# United States Patent and Trademark Office

APPLICATION NO.	FILING DATE	FIRST NAMED INVENTOR	ATTORNEY DOCKET NO.	CONFIRMATION NO.	
10/803,085	03/18/2004	Checrallah Kachouh	740116-511	4165	
22204 7:	22204 7590 . 10/20/2005			EXAMINER	
NIXON PEABODY, LLP			LUGO, CARLOS		
401 9TH STREET, NW SUITE 900			ART UNIT	PAPER NUMBER	
WASHINGTON, DC 20004-2128			3676

A	application No.	Applicant(s)			
Office Action Summary		1	10/803,085	KACHOUH, CHECRALLAH			
		E	xaminer	Art Unit			
			Carlos Lugo	3676			
The MAILING DATE of this communication appears on the cover sheet with the correspondence address Period for Reply							
A SHORTENED STATUTORY PERIOD FOR REPLY IS SET TO EXPIRE 3 MONTH(S) OR THIRTY (30) DAYS, WHICHEVER IS LONGER, FROM THE MAILING DATE OF THIS COMMUNICATION.  - Extensions of time may be available under the provisions of 37 CFR 1.136(a). In no event, however, may a reply be timely filed after SIX (6) MONTHS from the mailing date of this communication.  - If NO period for reply is specified above, the maximum statutory period will apply and will expire SIX (6) MONTHS from the mailing date of this communication.  - Failure to reply within the set or extended period for reply wil

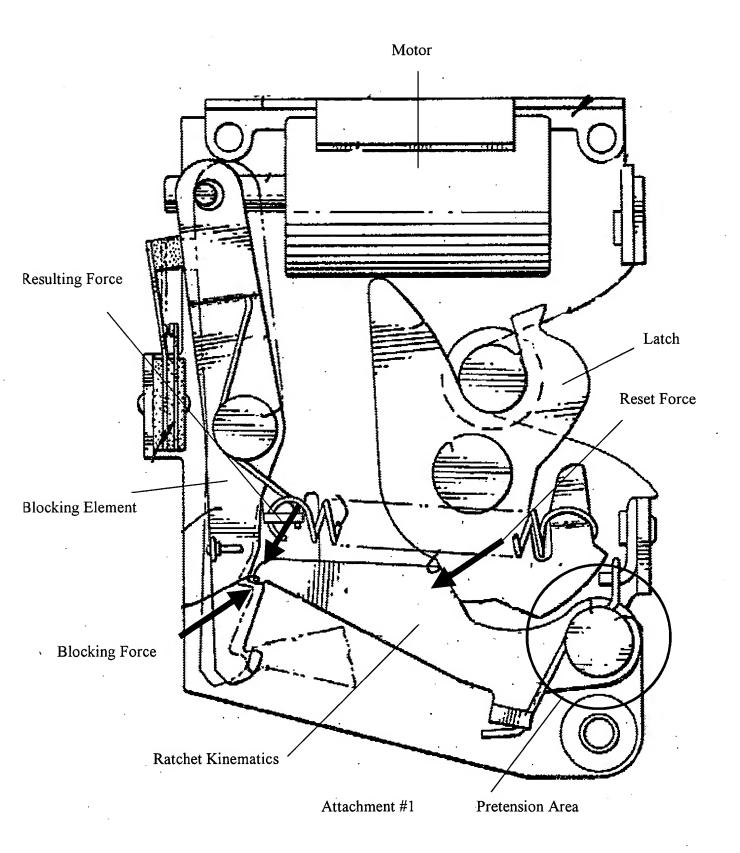
As to claim 2, Johnstone '761 illustrates that the ratchet kinematics (34) further comprises a step-down gearing, i.e., the amount of reset force which acts on the ratchet kinematics (34) by the latch (28) is greater than the resulting force acting on the blocking element (46) from the ratchet kinematics (see attachment #1). The step-

down gearing reduces a blocking force applied by the blocking element to block the latch (when the blocking element is moved, the force that the latch 28 exerts on the ratchet kinematics 34 reduces to zero the blocking force).

As to claims 14 and 15, Johnstone '761 illustrates that the transmission lever is pretensioned and wherein the blocking force of the blocking element opposes the pretensioning of the transmission lever (see attachment #1).

Aftachmat #2

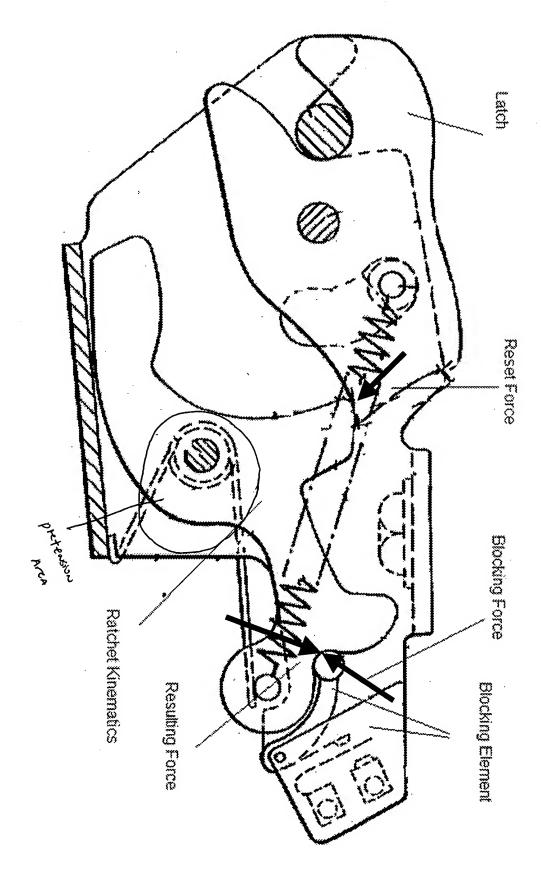
As to claim 2, Raffelsiefer illustrates that the ratchet kinematics (5') further comprises a step-down gearing, i.e., the amount of reset force that acts on the ratchet kinematics (5') by the latch (4') is greater than the resulting force acting on the blocking element (8' and 13') from the ratchet kinematics (see attachment #2). The step-down gearing reduces a blocking force applied by the blocking element to block the latch (when the blocking element is moved, the force that the latch 4' exerts on the ratchet kinematics 5' reduces to zero the blocking force).

As to claims 14 and 15, Raffelsiefer illustrates that the transmission lever is pretensioned and wherein the blocking force of the blocking element opposes the pretensioning of the transmission lever (see attachment #2).
